**DOCUMENT 00 90 00  
ADDENDUM**

**ADDENDUM NO. [1]                      Date: February 19, 2018**

**RE:                      MEDFORD AREA PUBLIC SCHOOL DISTRICT  
ATHLETIC COMPLEX IMPROVEMENTS  
1015 WEST BROADWAY  
MEDFORD, WISCONSIN 54451  
HSR PROJECT NO. 17067**

**C101R**

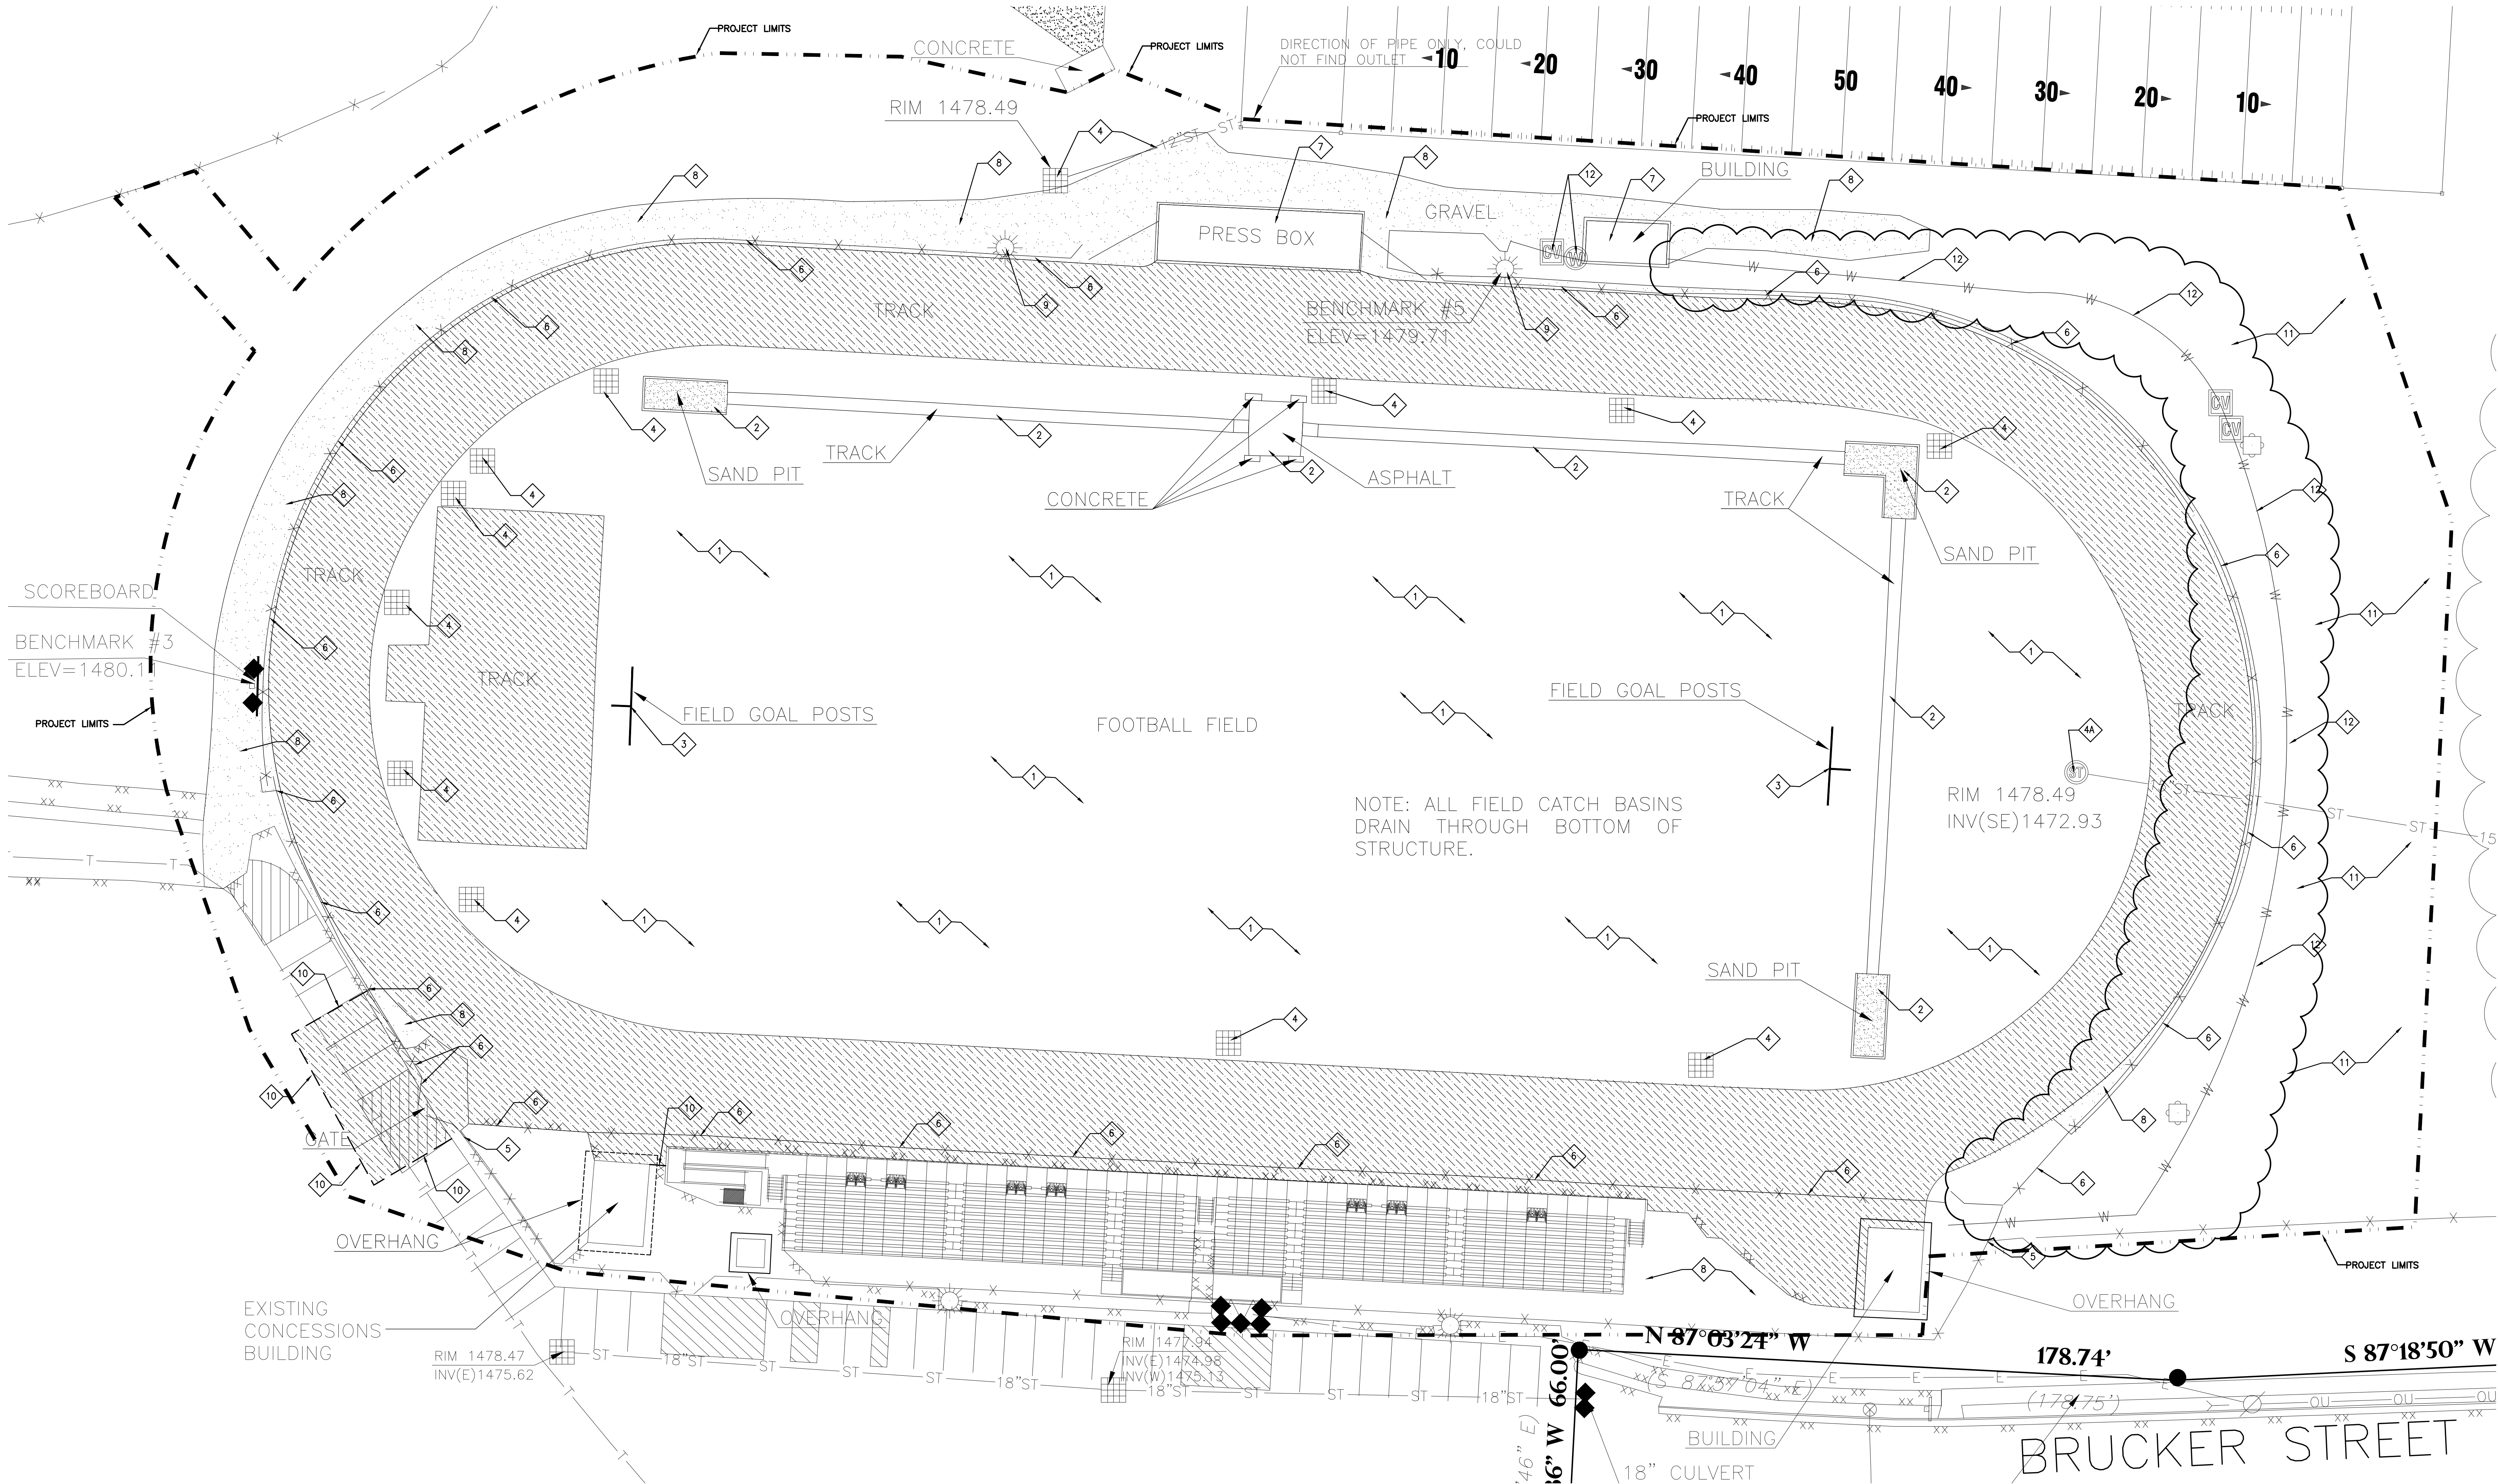
8. Sheet C101R: Site Demolition Plan 30 x 42 attached hereto
  - a. Electrical contractor shall salvage all existing light fixtures and related equipment on north wood stadium poles. Remove and salvage existing light wood poles.

- b. Electrical contractor to sawcut existing concrete pad at Musco panel to route new conduits below and up into the bottom of cabinet. Patch concrete pad after completion to match existing.

- c. Terminate, remove and cap existing water line east and north of existing running track that inhibits construction.
  - d. Owner to relocate existing water line. Coordinate site construction w/ owner.

- e. Any existing drain tile encountered and disturbed shall be cut, and remaining pipe capped and abandoned in place. System was supposed to have been installed 18-24" below grade. No confirmation of current depth available.

C102R

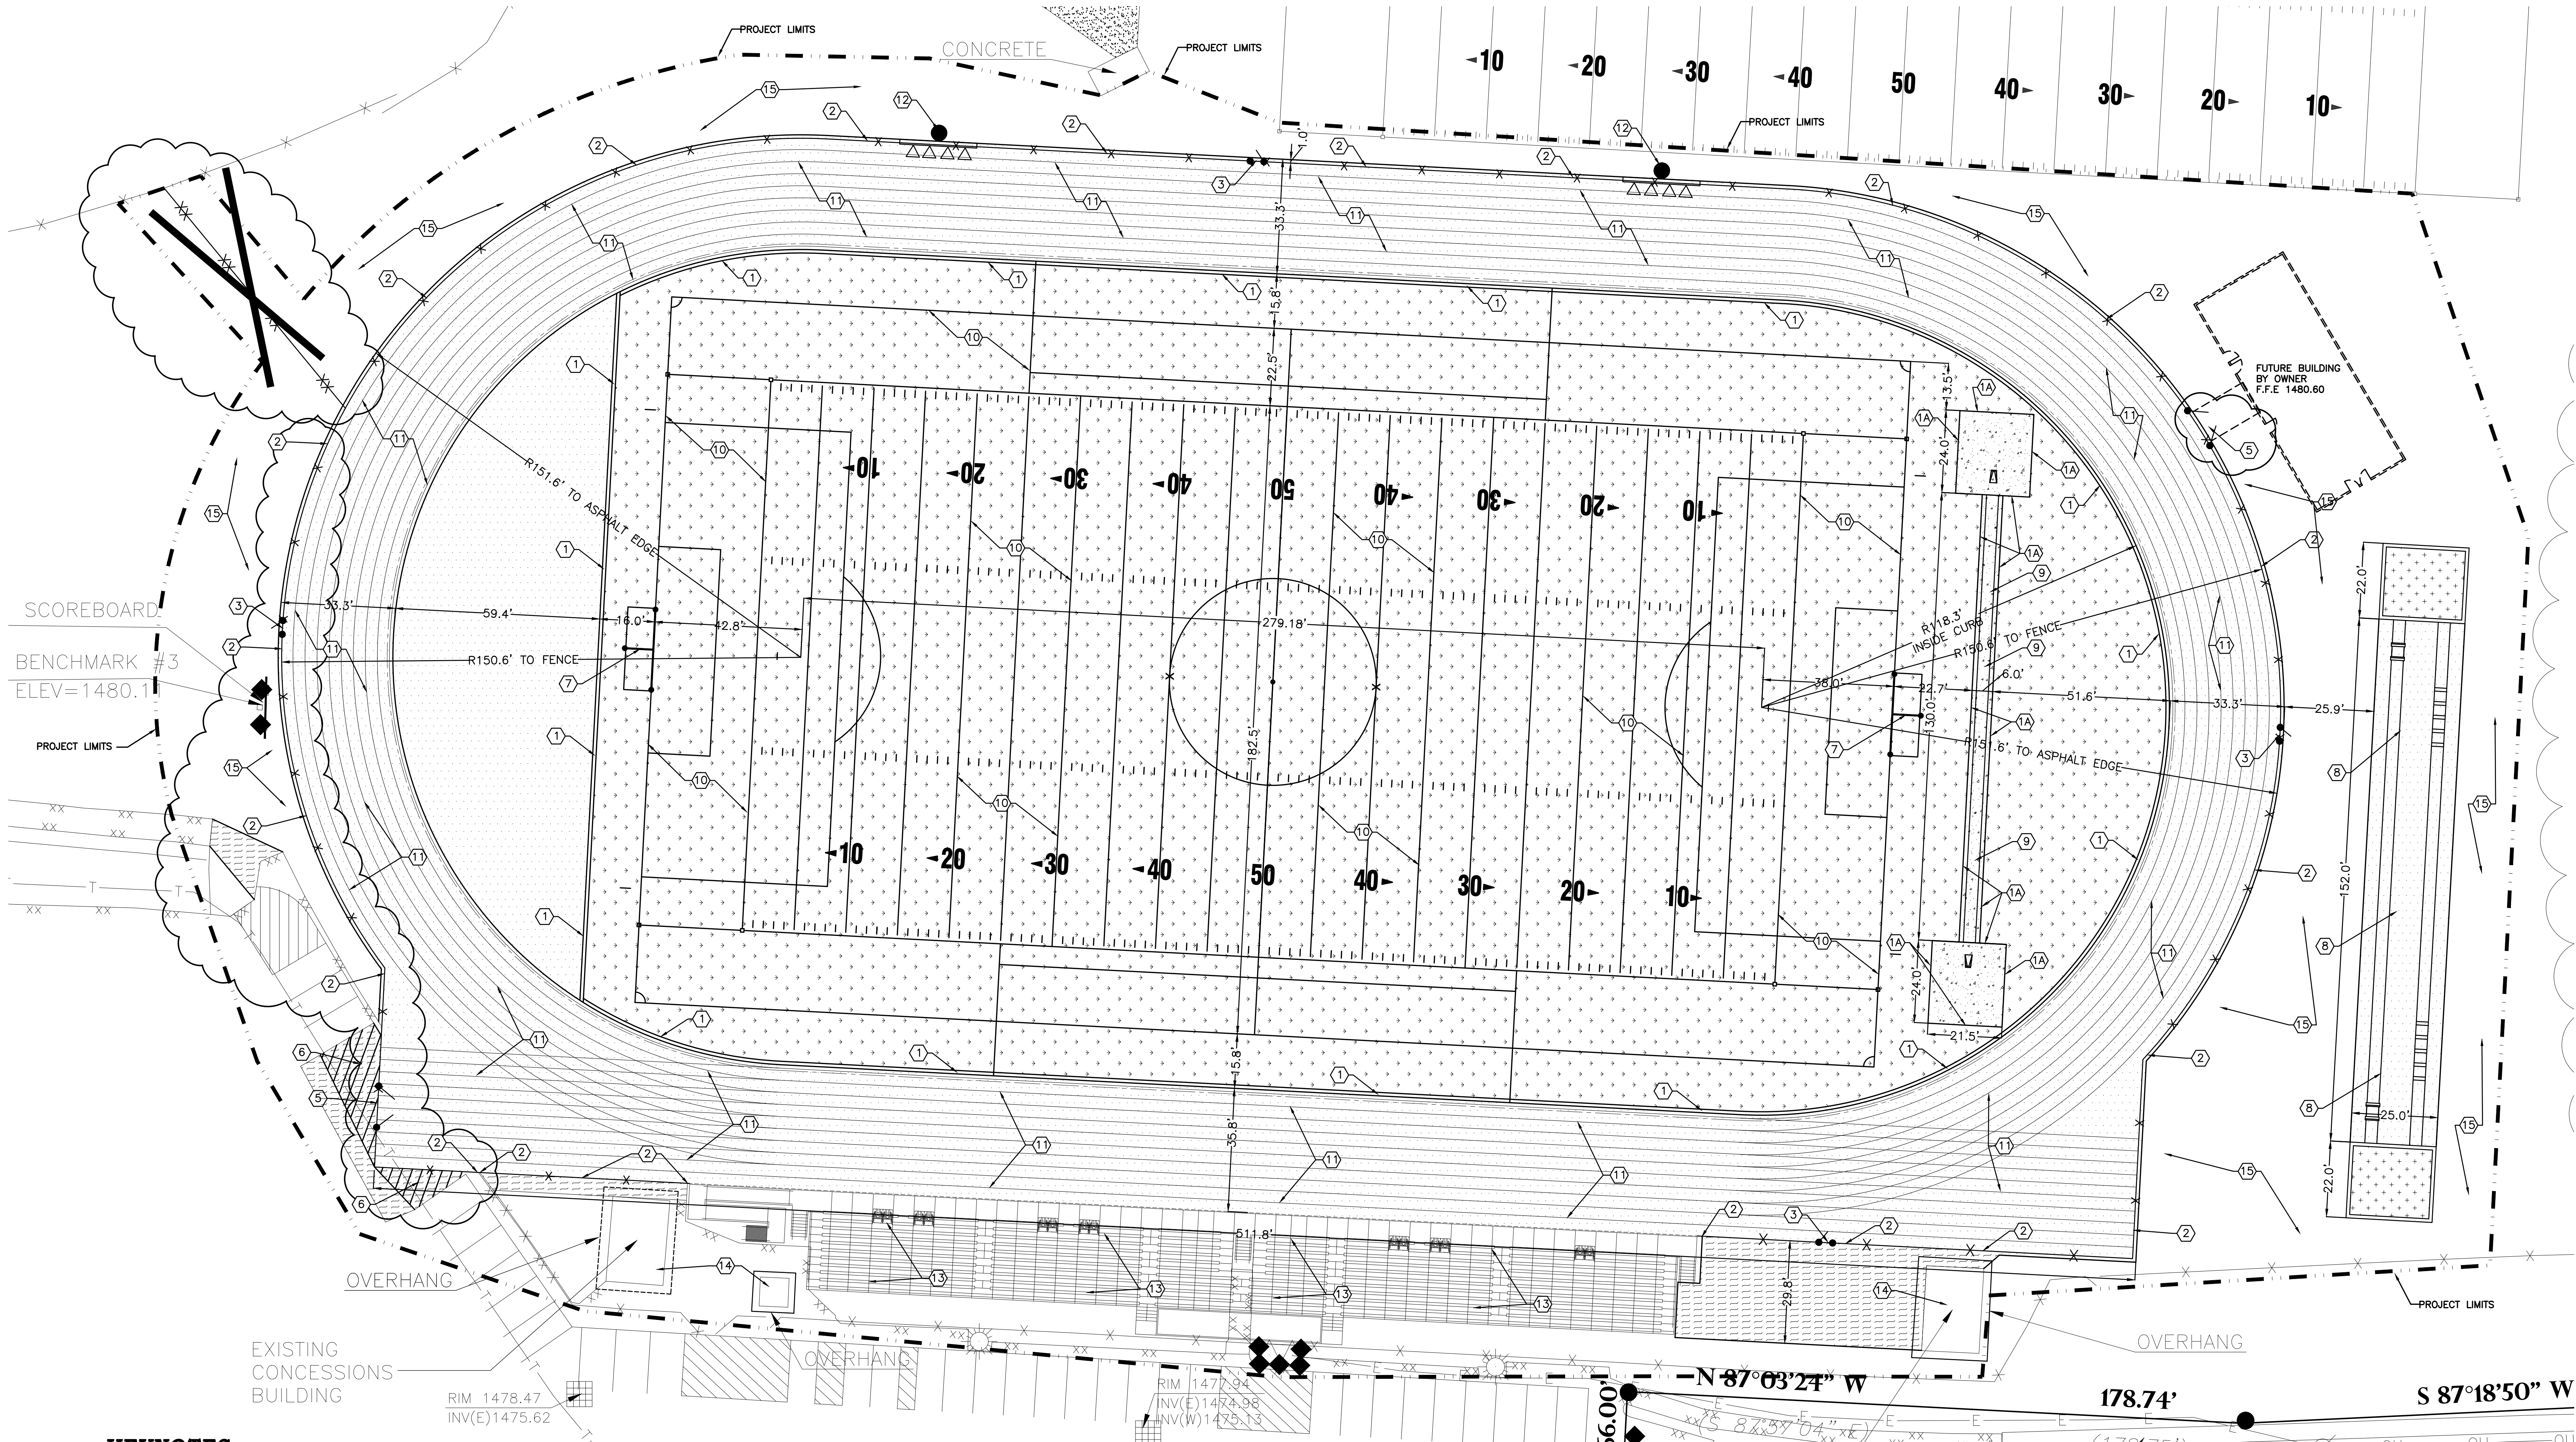
9. Sheet C102R: SITE LAYOUT PLAN 30 x 42 attached hereto
  - a. Delete Keynote 4. Omit proposed 6' high chain link fence located at the NW corner of the proposed running track connecting to the existing baseball field perimeter fence.

- b. Proposed chain link fence around west radius of running track shall be 4' high in lieu of 6' high.
  - c. Install additional asphalt pavement and base course to connect the existing walking path to the parking lot at SW corner of track.

- d. Install new 12' wide double service gate at the NE corner of track for access to the future storage building constructed by owner.
10. Sheet C104R: SITE GRADING PLAN 30 x 42 attached hereto
